Design review report

Code:	AE-33285
Rev:	5
Date:	2021-02-01
Page:	1/ 6

Aim of this document is to describe suggestions and corrections that Telit advises to improve Ovoo Electronics B100AA application that integrates Telit GE910-QUAD V3 and BlueMod S50 modules.

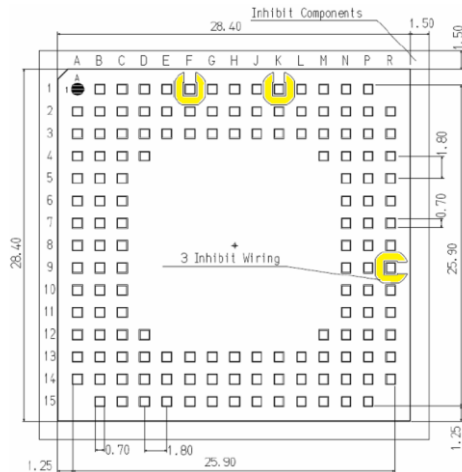
- ❗ Kindly make sure the BlueMod+S50 UART lines are connected to HOST MCU as shown below,

- ❗ We recommend placing test points for BOOT0 pin, UART-RXD, UART-TXD, UART-RTS# and UART-CTS#. This will be useful for Regulatory approval purpose.

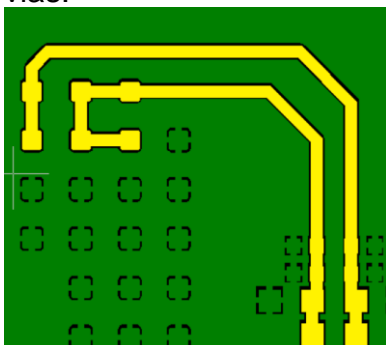
- STOP** Your design is not RF proof; the PCB has many tracks exposed creating loops that pick-up RF energy; they can generate high frequency intermodulation harmonics that irradiate very efficiently producing unwanted spurious emissions and furthermore it is lacking in RF decoupling.

Reroute the PCB design to have minimum lines running on external layers, burying the tracks in the inner layers and having all external layers and borders like ground

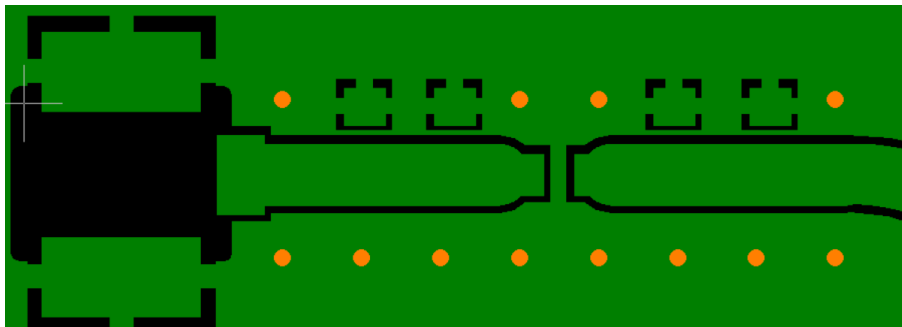
Your RF line is a waveguide with characteristic impedance of about 50 Ohms, but it has not a uniform layout. We remind you that all waveguide parameters (**Width, Gap** and Height) must remain constant all track long, including the matching network pads otherwise this can lead to characteristic impedance discontinuities.

In your waveguides, width and Gap change in several points along the track introducing discontinuities to the characteristic impedance.

In order to avoid discontinuities, we suggest routing your waveguide as depicted below:
